From: Simon Tucker <SJT@dtatransportation.co.uk>
Sent: Thursday, December 14, 2023 11:49 AM
To: Babatunde.Adekoya-Serrano@nationalhighways.co.uk
Cc: Peter Simpson <Peter@posimpson.com>; Mark Simpson <mark@extraroomselfstorage.co.uk>
Subject: 25192 : Redgate Site Extension (LPA Ref: 21/1492/FUL)

AndrewLarge
surveyors LTD
FORMER COUNTRYWIDE STORE
ATHERSTONE ROAD
CALDECOTE
NUNEATON
CV10 0RY
ACCESS PLAN
SCALE: 1:200@A1

Detailed Surface Water Drainage Strategy - Redgate Depot

Figure 1-2: Environment Agency 2022 1m LiDAR DTM

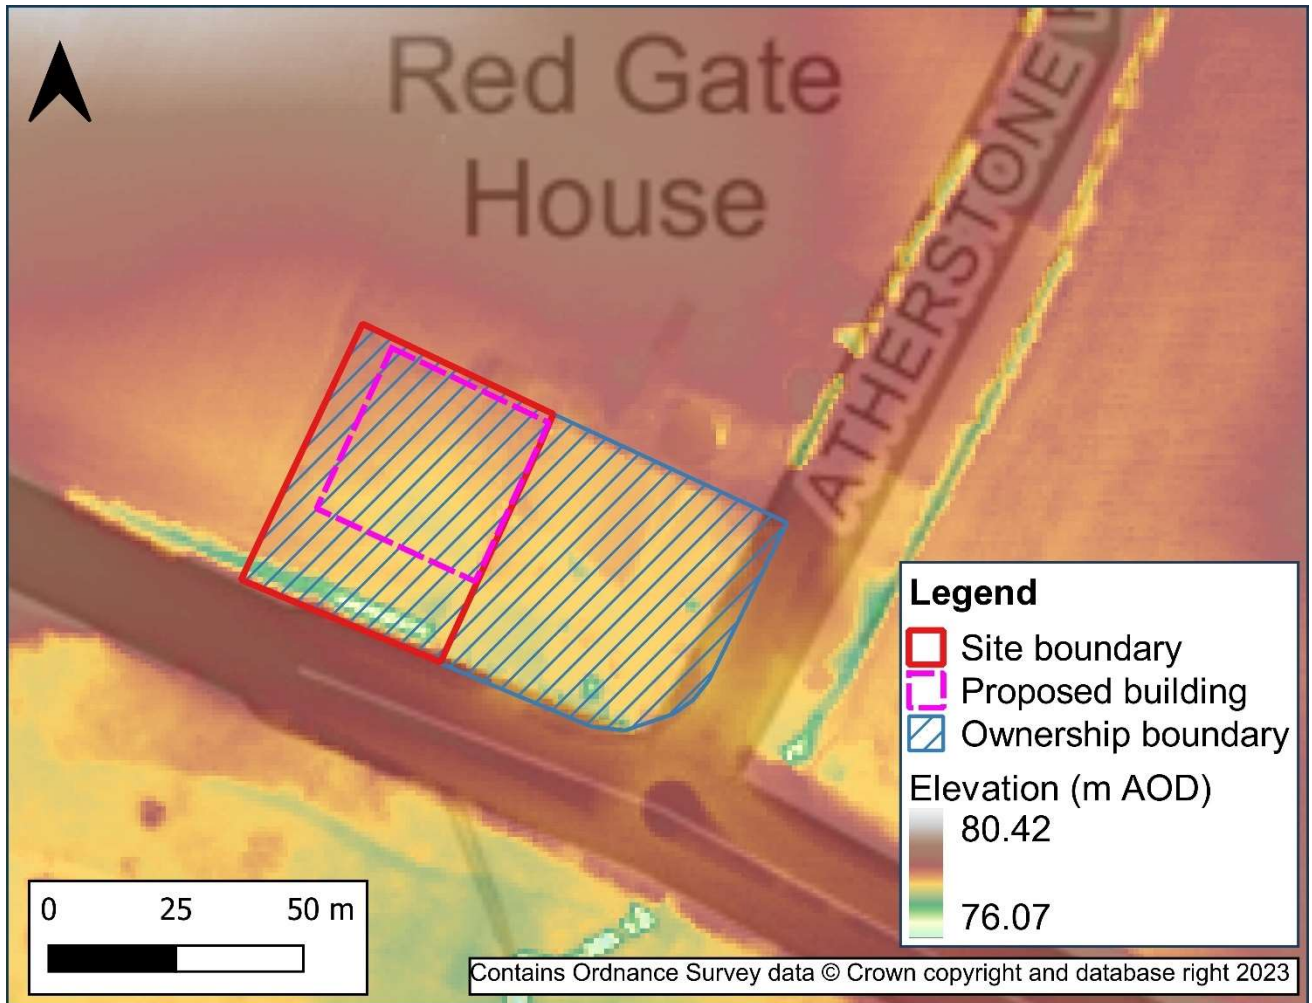
After liaising with our drainage team, it has come to our attention that more clarification is required in terms of how your proposal will offset on to our network. It is also a concern for us with regards to your access on the A5. You have mentioned that it has been well established, but it poses a safety risk to other road users who are not your customers. Please attempt to find alternative access and refer to DfT Circular 01/22 for guidance.

The site is below the level of the A5. This is demonstrated in Figure 1.2 and Appendix B of the Detailed Surface Water Drainage Strategy Report. In the scenarios that have been modelled (baseline and post-development) there is no increase in predicted flood risk to the A5 as a result of this development.
